ELECTRONICS INDUSTRY PUBLIC COMPANY LIMITED

Product Change Notification

Change in Package design

Package Outline Comparison

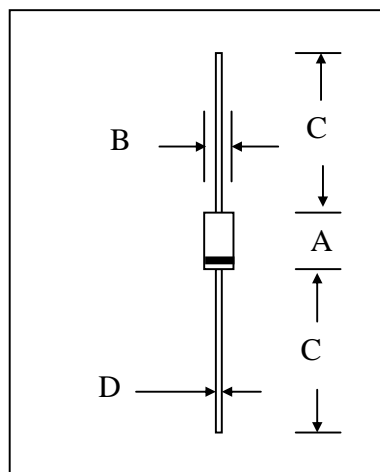
Effective on Jan 3, 2009, the Package change will be made to the product series as follows:

1N53xx Series - change the package from D2A to DO-15

P6KE Series - change the package from D2A to DO-15

BZW06 Series - change the package from D2 to DO-15

Dimension		D2 Package		D2A Package		DO-15 Package	
		(Ins.)	(mm)	(Ins.)	(mm)	(Ins.)	(mm)
A	Max.	0.284	7.20	0.284	7.20	0.300	7.60
	Min.	0.268	6.81	0.268	6.81	0.230	5.80
B	Max.	0.161	4.10	0.161	4.10	0.140	3.60
	Min.	0.154	3.90	0.154	3.90	0.104	2.60
C	Min.	1.000	25.4	1.000	25.4	1.000	25.4
D	Max.	0.034	0.86	0.040	1.02	0.034	0.86
	Min.	0.028	0.71	0.0385	0.98	0.028	0.71
